BRITISH COLUMBIA TIMBER SALES, CHINOOK BUSINESS AREA

PHASE 3 REVIEW OF TSL TA0521
BLOCKS G03B4P2 & G043B4P8
MT ELPHINSTONE SOUTH

Polar File: 740202
BCTS Contract: 10005-40/PD21TBF001
FINAL REPORT
JUNE 2023

Re: Phase 3 Review of TSL TA0521, Blocks G03B4P2 & G043B4P8, Mt Elphinstone South

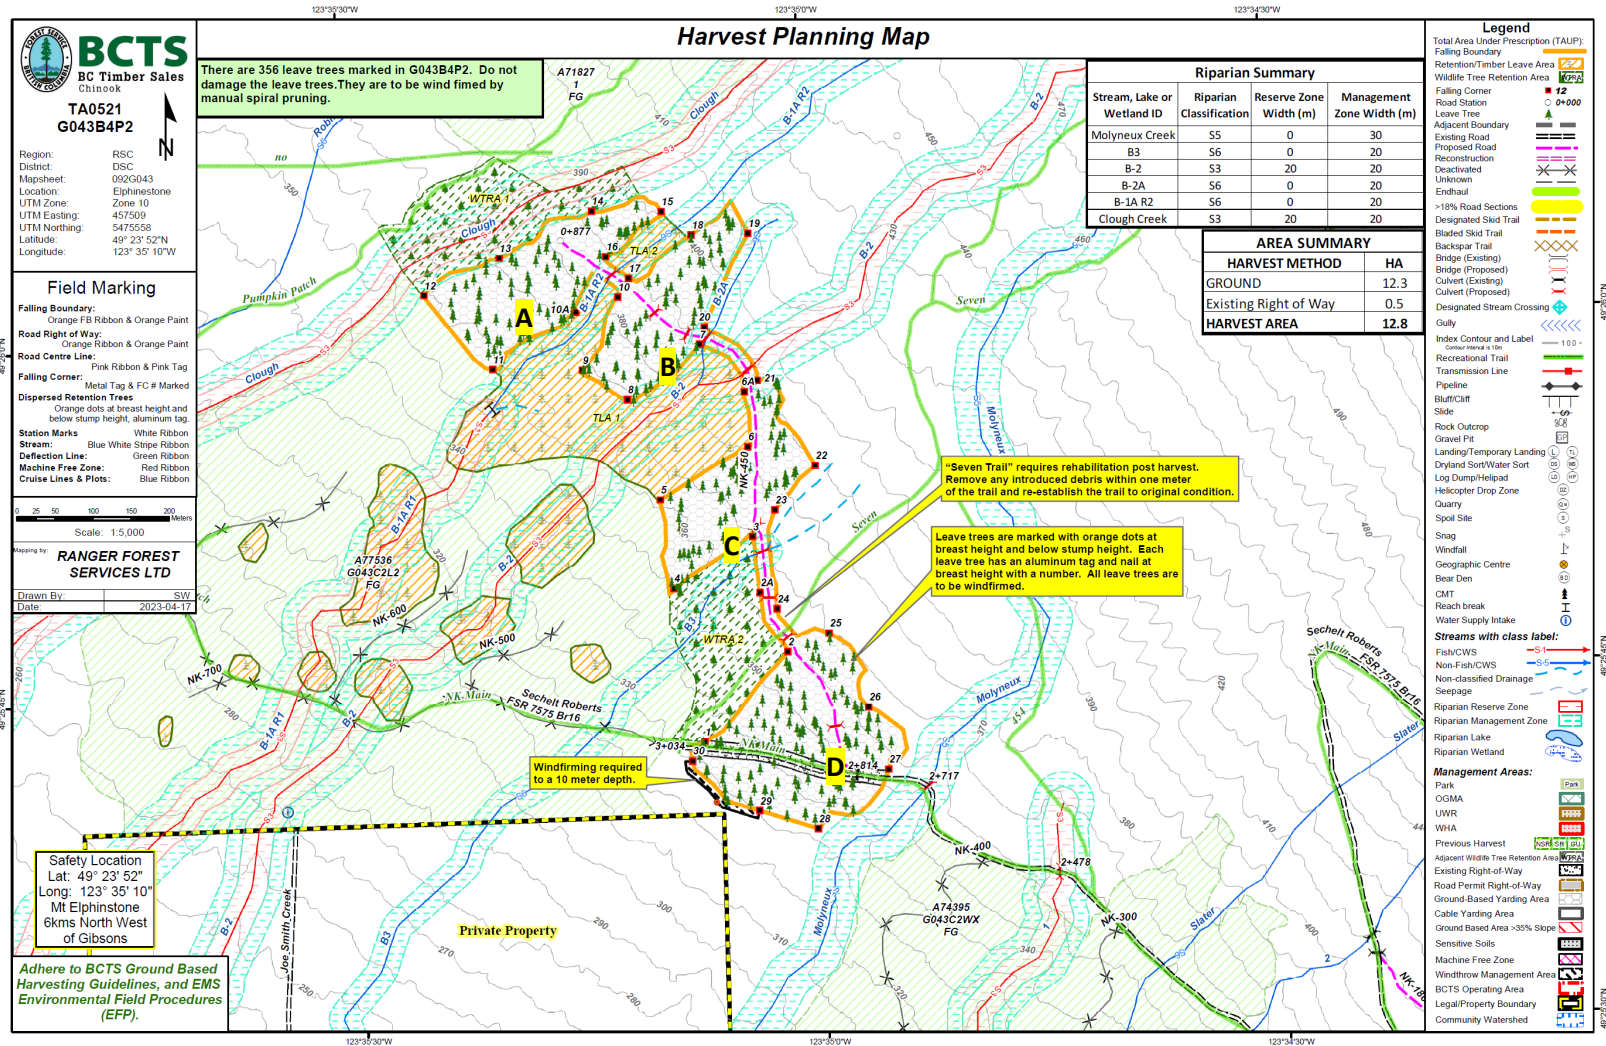
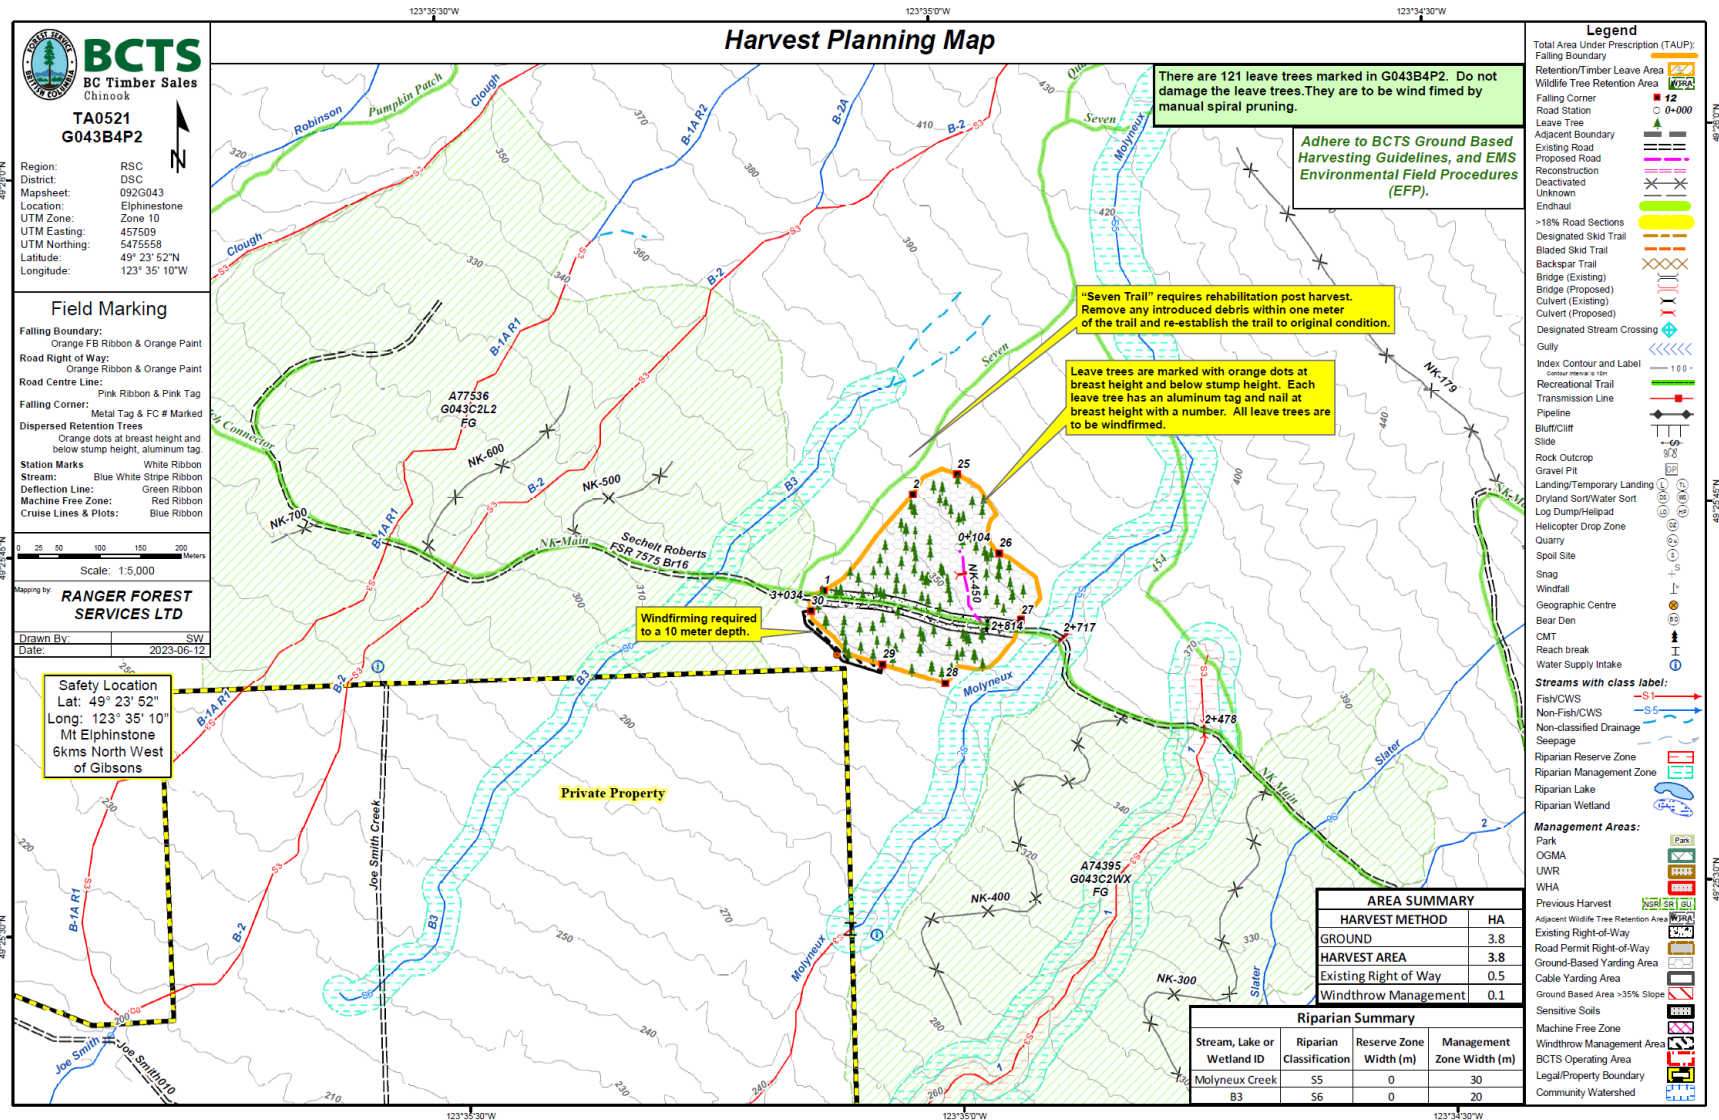
- Opening A is located within the Clough Creek Watershed, opening B, C, and the majority of D are located within the Joe Smith Creek Watershed. The southeastern portion of opening D is located within the Molyneux Creek Watershed (FIGURE 2).

- The surface of soils were dry on the date of the field review.
- The mapped channel at the location of the road alignment between opening A and B (mapped as B-1A on FIGURE 2) is 0.5 m wide and was dry during the time of the field visit. The channel has a cobble streambed with some gravel deposits and some incision was noted. Abundant in-stream and suspended wood were present.

- Between opening B and C, the planned road alignment crosses mapped channels B-2A and B-2⁵, which join roughly 30 m below the road. Channel B-2A is 0.5 m wide with no surface flow noted during the time of the field review. Some gravel deposits were noted and abundant in-stream wood was present. Joe Smith Creek is 2.0-2.5 m wide at the road crossing and minor surface flow was present during the time of the field review. The channel has a bed comprised of small boulder and cobble (FIGURE 4) and incision of up to 0.5 m was noted. Abundant in-stream wood and debris were present. Active sediment transport is likely to occur in response to fall and winter rainstorms.

Given the preliminary area of planned blocks G043B4P2 and G043B4P8 presented in TABLE 1, the recommended ECA threshold was projected to be exceeded in the Joe Smith Creek Watershed and Leek Creek drainage area within BCTS Chart. To maintain the current peak flow hazard rating in Joe Smith Creek, ECAs should not be increased by more than 3.9 ha overall currently (TABLE 1). Roughly 9.3 ha of block G043B4P2 was planned in the Joe Smith Creek Watershed under the preliminary harvest plan, exceeding the recommended threshold by 5.4 ha. To meet the management recommendations put forth, the portion of the planned block within the Joe Smith Creek Watershed would have to either be reduced in size or basal area retention increased. Alternatively, the planned block could be deferred until 5.4 ha of hydrologic recovery has occurred, which is projected in roughly 15-20 years or by the year 2036 – 2041 (TABLE E.1 in Polar, 2023).

1. Establish machine free zones (MFZs) 5 m wide on each side of S6 streams within the blocks and minimize, where practical, crossings of S6 streams by heavy equipment. Based on FIGURE 2 and FIGURE 3, there are three S6 streams that pass through planned block G043B4P2 and one S6 stream near the eastern border of planned block G043B4P8.

As per the recommendations put forth herein, planned block G043B4P2 has been reduced in size by 8.5 ha by removing openings A, B, and C. As such, 3.7 ha of the block is located within the Joe Smith Creek Watershed and 0.8 ha of the block is located in the Molyneux Creek Watershed. Given the projected ECAs in TABLE 3, the peak flow hazard in Molyneux Creek and Joe Smith Creek is expected to remain low within BCTS Chart and is not projected to increase at the POIs downstream of BCTS Chart following development of planned block G043B4P2.

FIGURE 6 Amended harvest planning map of TSL TA0521, Block G043B4P2 based on recommendations for the preliminary Phase 3 draft report (from BC Timber Sales June 13, 2023).

FIGURE 3 Preliminary harvest planning map of TSL TA0521, Block G043B4P8 (from BC Timber Sales 18 April, 2023). Note that these plans were subsequently revised by BCTS based on the findings in Phase 3. Refer to FIGURE 7 for the revised plans.

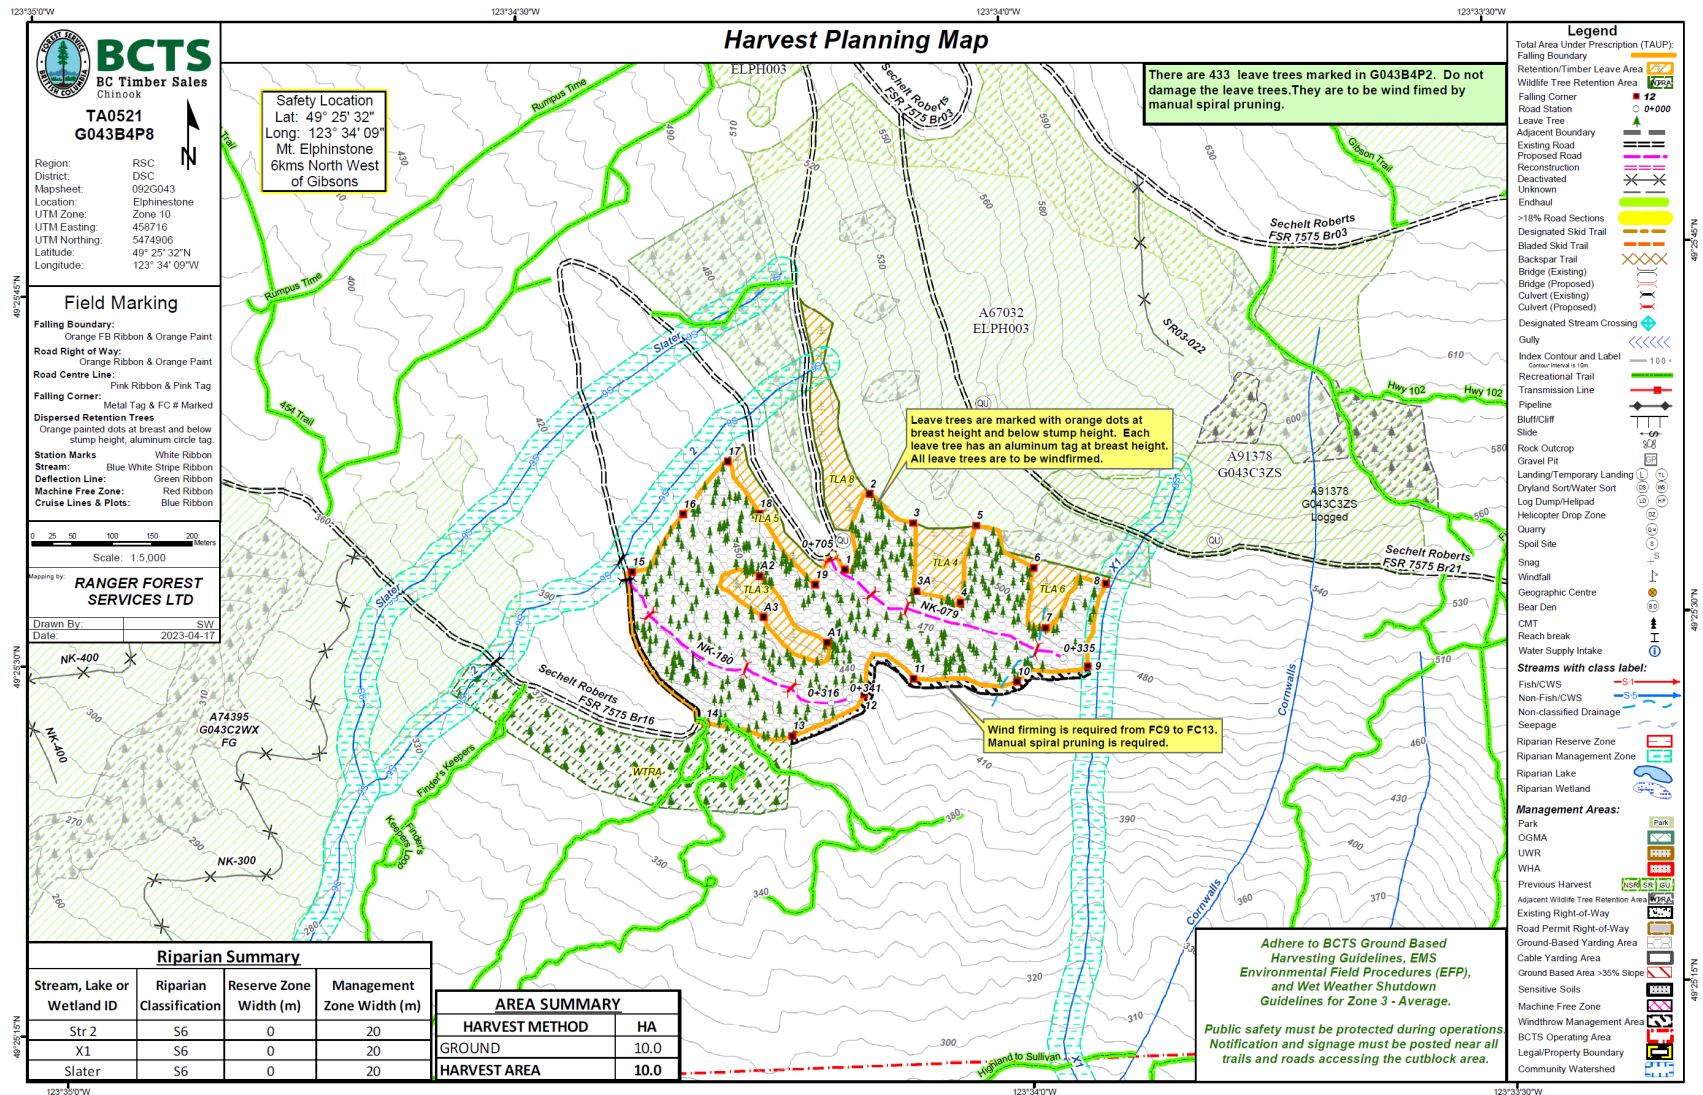
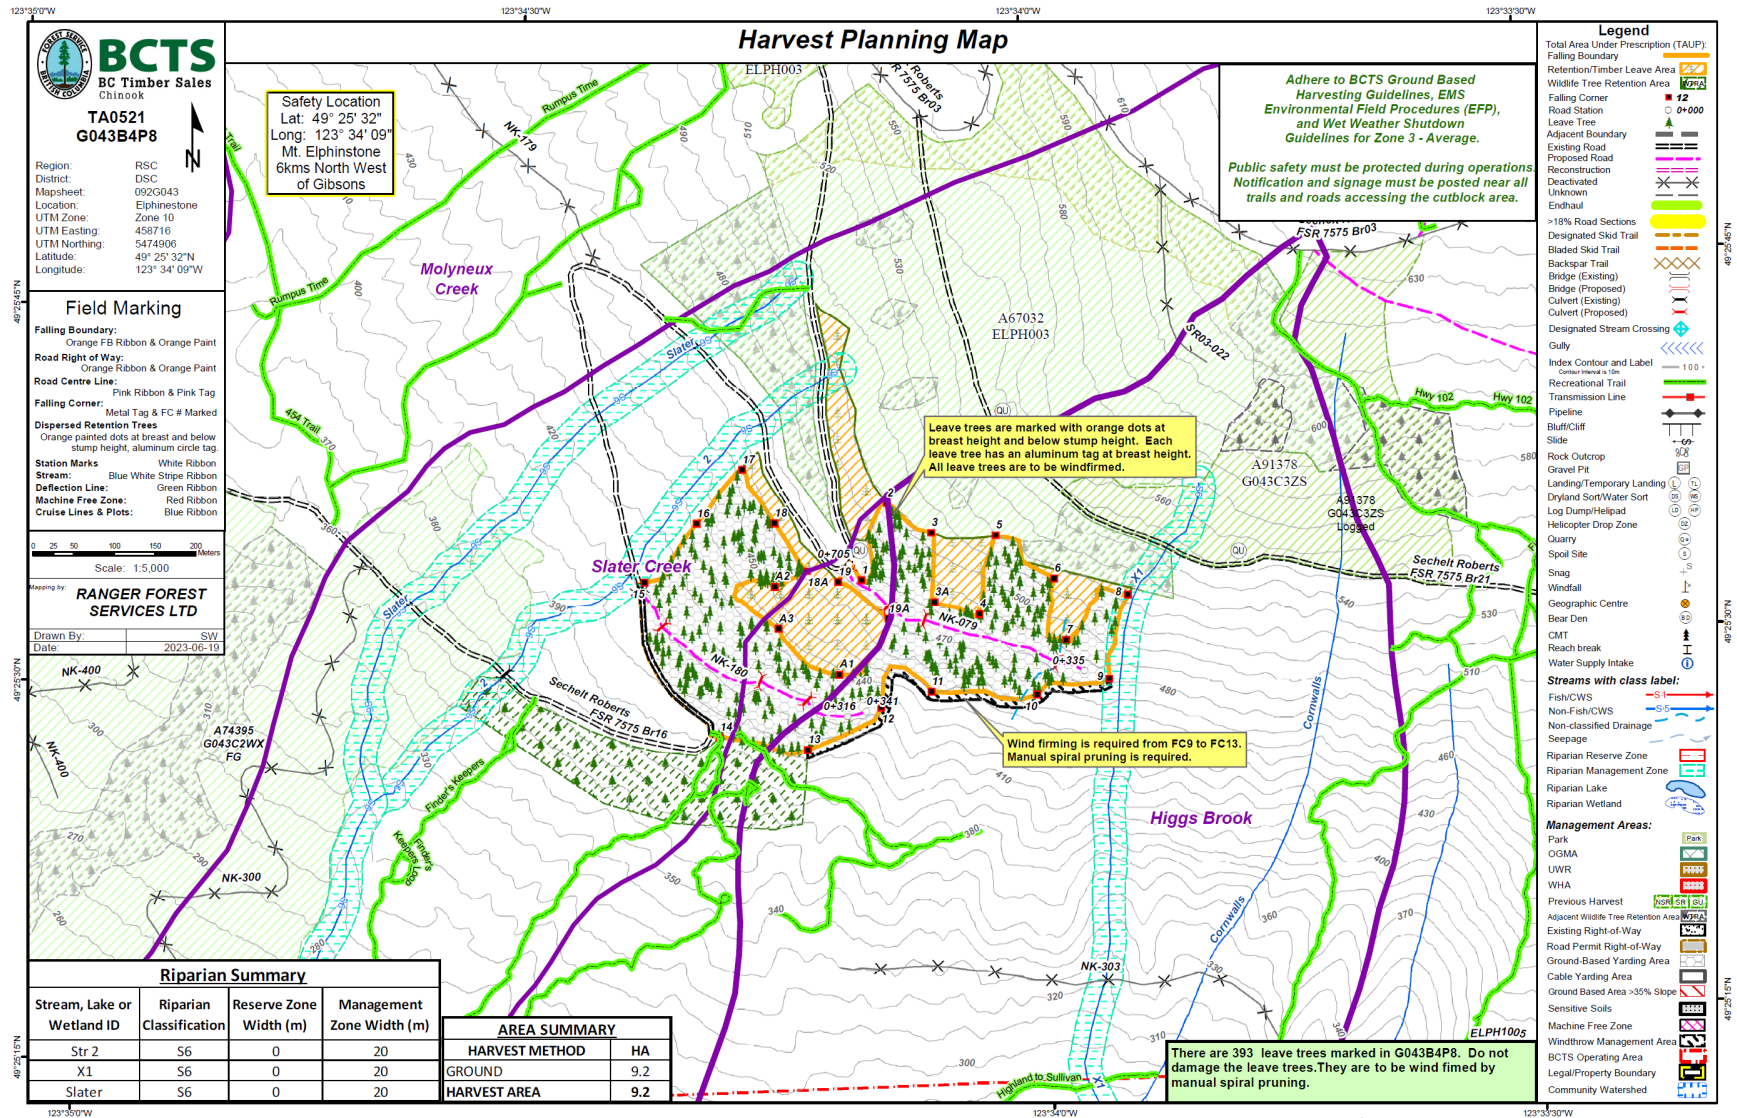
- Hillslope gradients range from 30% in the southwest portion of the block (FIGURE 5) to 45% in the northeast portion. The hillslopes below the northeastern portion of the block steepen to roughly 60%⁶.

To maintain a low peak flow hazard within the portion of Leek Creek above BCTS Chart boundary, ECAs should not be increased by more than 1.6 ha (TABLE 1). Approximately 2.4 ha of block G043B4P8 was planned within BCTS Chart in the Leek Creek drainage area. As such, it was recommended that the portion of block G043B4P8 within BCTS Chart be reduced by 0.8 ha, either by reducing block size or increasing basal area retention.

2. One NCD is crossed by the upper road alignment in planned block G043B4P8. Excessive soil disturbance of NCDs followed by high runoff can result in erosion, downslope sedimentation, and in some cases, conversion of NCDs to S6 channels. In effect, groundwater flow becomes more rapidly flowing surface flow. To minimize the risk of this occurring, equipment operators should be instructed to minimizing trafficking along or across such areas where practical.
3. Given the steeper slopes in the northeast portion of planned block G043B4P8, we recommend out sloping the road to distribute runoff to the slopes below and minimize slope instability.

Similarly, the timber leave area for planned block G043B4P8 has been increased, reducing the opening size of the block by 0.8 ha. Following the amended planned development, ECAs within the BCTS portion of the Leek Creek drainage area are projected to increase by 1.5 ha. As such, peak flow hazard in the Leek Creek drainage area is expected to remain low within BCTS Chart and is not projected to increase downstream of BCTS Chart.

FIGURE 7 Amended harvest planning map of TSL TA0521, Block G043B4P8 based on recommendations for the preliminary Phase 3 draft report (from BC Timber Sales June 19, 2023).
